**LICENSE AMENDMENT REQUEST TO CHANGE TECHNICAL SPECIFICATIONS IN
SUPPORT OF PRNM AND ARTS / MELLLA IMPLEMENTATION**

Columbia Generating Station Power Range Neutron
Monitoring System Design Analysis Report

NEDO-33697

**Columbia Generating Station
Power Range Neutron Monitoring System
Design Analysis Report**

Figure 1 - RBM Communication Links

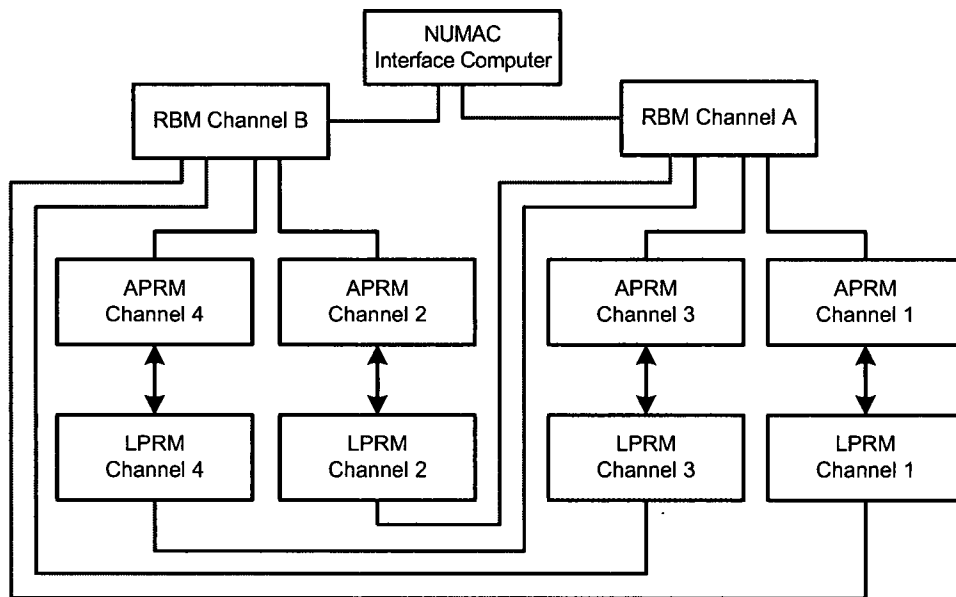
The interdivisional interfaces identified in the original NRC request pertained to the use of Power Range Communication Interface (PCI) modules which provide certain functionality

similar to that provided by the RBMs used within the CGS PRNM, but also provide additional functionality not found in the RBMs – nor required for the CGS PRNM.

The additional functionality provided by the four PCI modules – each dedicated to a single APRM channel – required interdivisional interfaces between those PCIs.

As shown in Figure 1, there are no communication links between the two RBMs used in the CGS PRNM, and therefore the concerns related to the interdivisional interfaces between PCI modules are not applicable to the CGS PRNM.
